Project	IEEE 802.16 Broadband Wireless Access Working Group < http://ieee802.org/16 >	
Title	Common PHY issue & Messages for Neighbor Discovery Using CTS	
Date Submitted	2005-09-06	
Source(s)	Wu Xuyong Huawei Huawei Industrial Base, Bantian, Longgang, Shenzhen 518129 P.R.C	Voice: +86-755-28971677 Fax: +86-755-28972045 wuxuyong@huawei.com
Re:	80216h-05_018 : Call for Contributions IEEE 802.16's License-Exempt (LE) Task Group. 2005-08-18	
Abstract	Provide a PHY independent symbol and a frame structure in using CTS slots	
Purpose	Consolidate the neighbor discovery procedure in ad-hoc fashion	
Notice	This document has been prepared to assist IEEE 802.16. It is offered as a basis for discussion and is not binding on the contributing individual(s) or organization(s). The material in this document is subject to change in form and content after further study. The contributor(s) reserve(s) the right to add, amend or withdraw material contained herein.

Common PHY issue & Messages for Neighbor Discovery Using CTS

figure8: Timing of Coexistence Time Slot

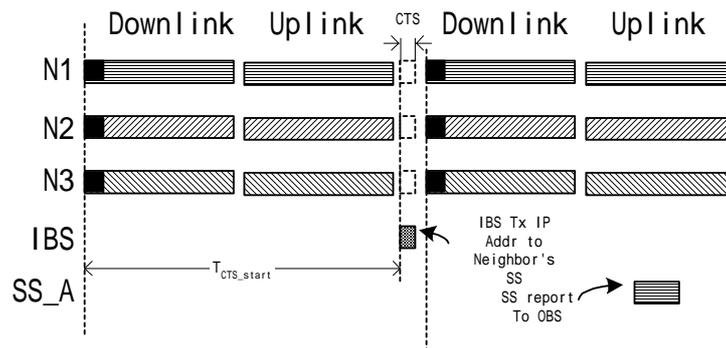
[Change the figure8 and figure 9 as indicated]

Not to break the downlink PDU, and to prevent overhead of more preamble and gaps. CTS slots shall be located before RTG/TTG in TTD frame structure or before the preamble of downlink frame in FDD frame structure. To unify the location in these two kind of duplexing frame, CTS slots in FDD frame shall be put into the downlink structure right before the preamble, and shall be located right before RTG in TDD frame.
